ADDENDUM NO. 1

DEERFIELD
Federal Aid Project No. BFL(BR-OFF)-0032(052)X
Bridge Replacement, D-06-001,
Upper Road Over Deerfield River

Transmitting revisions to the Contract Documents as follows:

Revised Plan Sheets 47, 49, 50, 51, 52, 61 & 63 of 92.

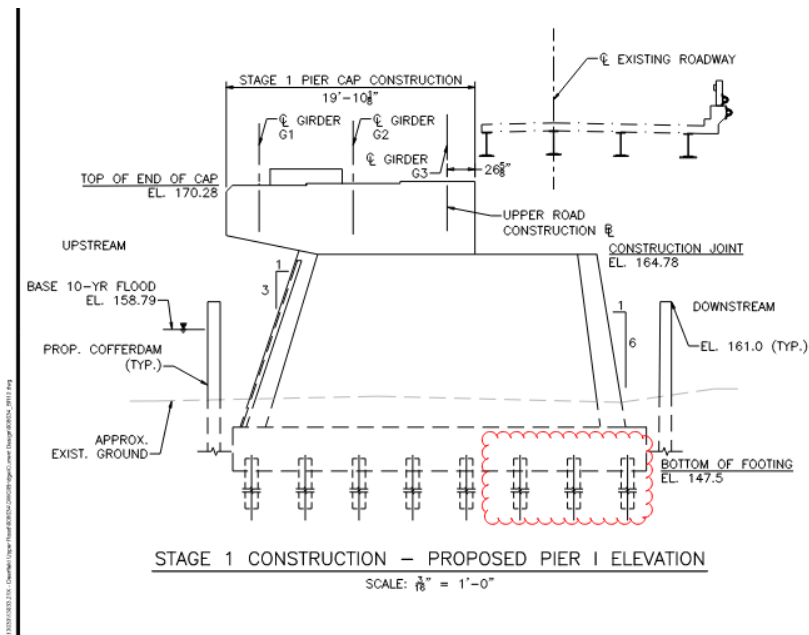
Item No. 944.124 – Steel Pile Splices, HP12x84 identifies a quantity of 46 pile splices. Based on the contract drawings and the limited headroom conditions at several locations, there appear to be three rows of piles that will require a substantially greater number of splices than indicated. Please refer to the sketch below for reference. Kindly confirm the criteria/restrictions on splicing.

See revised Plan Sheets 47 of 92 (11 of 41), 49 of 92 (13 of 41), 50 of 92 (14 of 41), 52 of 92 (16 of 41), 61 of 92 (25 of 41), and 63 of 92 (27 of 41) issued via this addendum.

VERIZON MANHOLE DETAILS

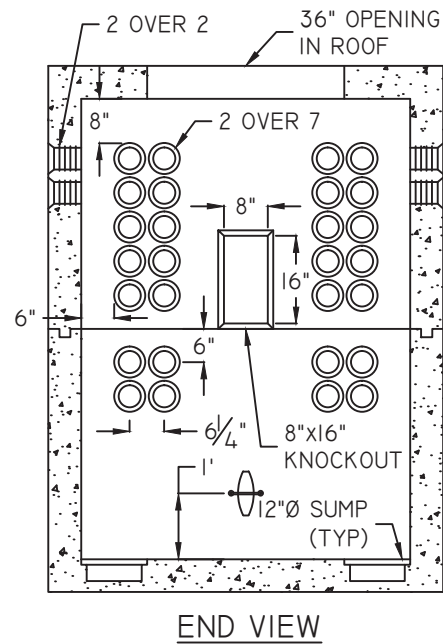
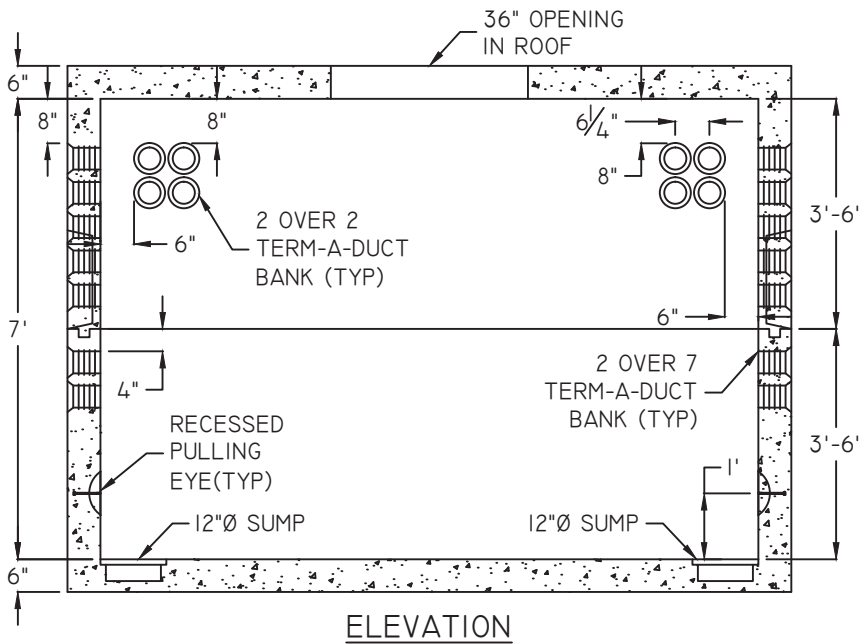
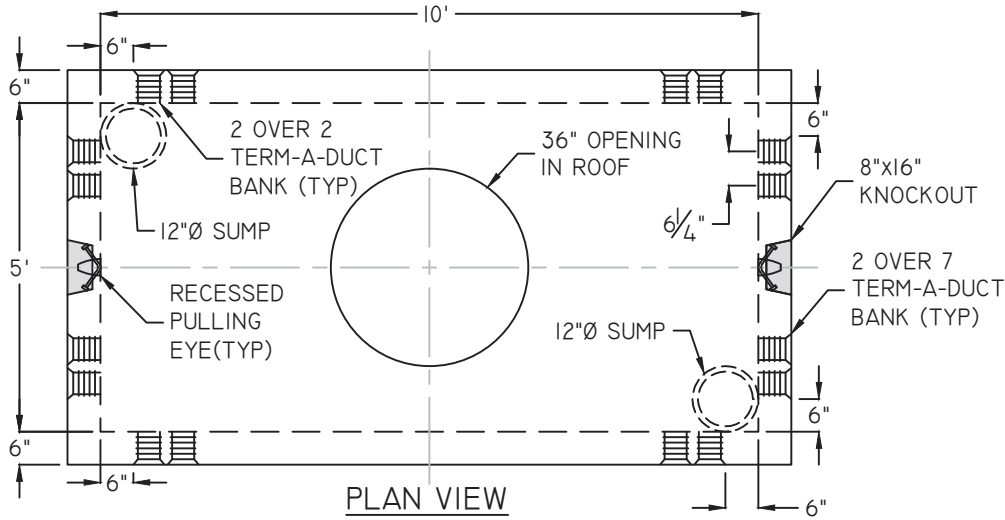
There is a detail for the Eversource manhole in the specifications but nothing on the Verizon or Comcast manholes and handholes. Please provide details.

See attached Document A00803 issued via this addendum. The Contractor shall verify all utility structure specifications with Verizon and Comcast and coordinate a review and approval prior to procurement and installation.
